Rainforth Grau Architects Project No.22-1515

DSA File and Application No. 39-73 / 02-120733 PTN: 75499-180

ADDENDUM NO. 1

Villalovoz Elementary School, Inc. #2 Tracy, California

1 BUILDING A - DEMO RESTROOMS A118 AND A119

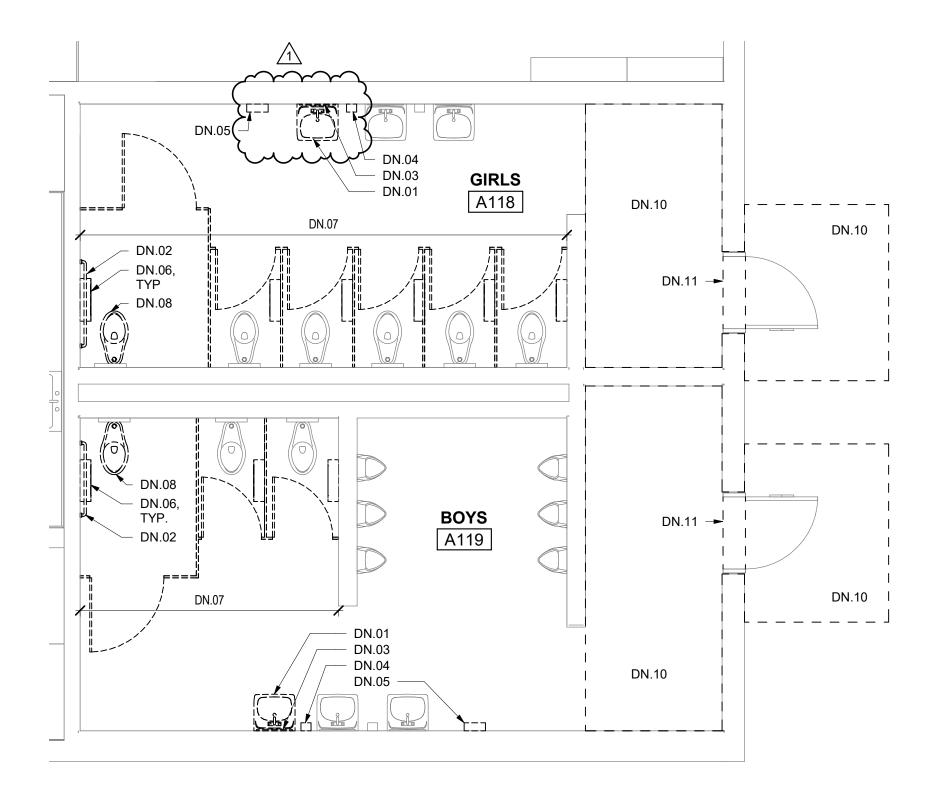
- 1. REVISE detail 1, BUILDING A DEMO RESTROOMS A118 AND A119 per sheet AD1.04 included with this addendum.
- E. Sheet A2.1.8-2, ROOF PLAN BUILDING A
 - 1. DELETE sheet in its entirety and REPLACE with sheet AD1.05 included with this addendum

PARAPET AT MANSARD 9/

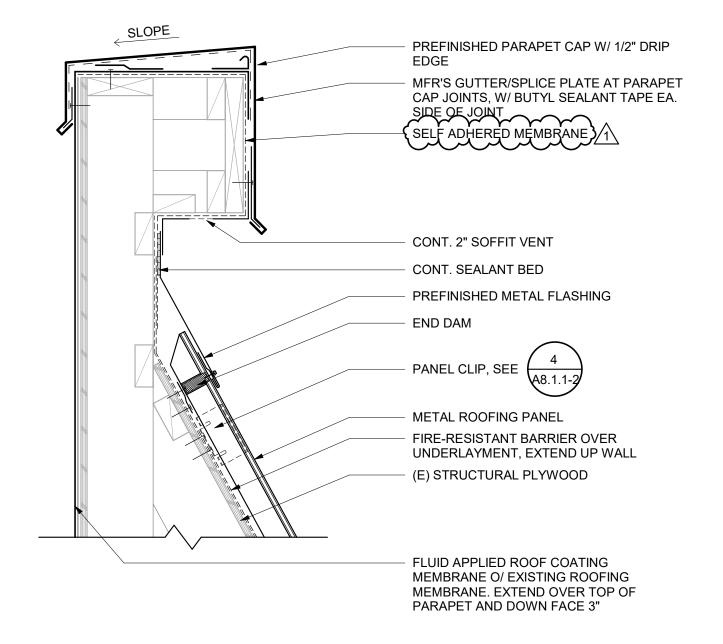
- 1. REVISE detail 9, PARAPET AT MANSARD per sheet AD1.12 included with this addendum
- M. Sheet E0.0.1-2, SHEET INDEX AND SYMBOLS
 - 1. DELETE sheet in its entirety and REPLACE with sheet AD1.13 included with this addendum.
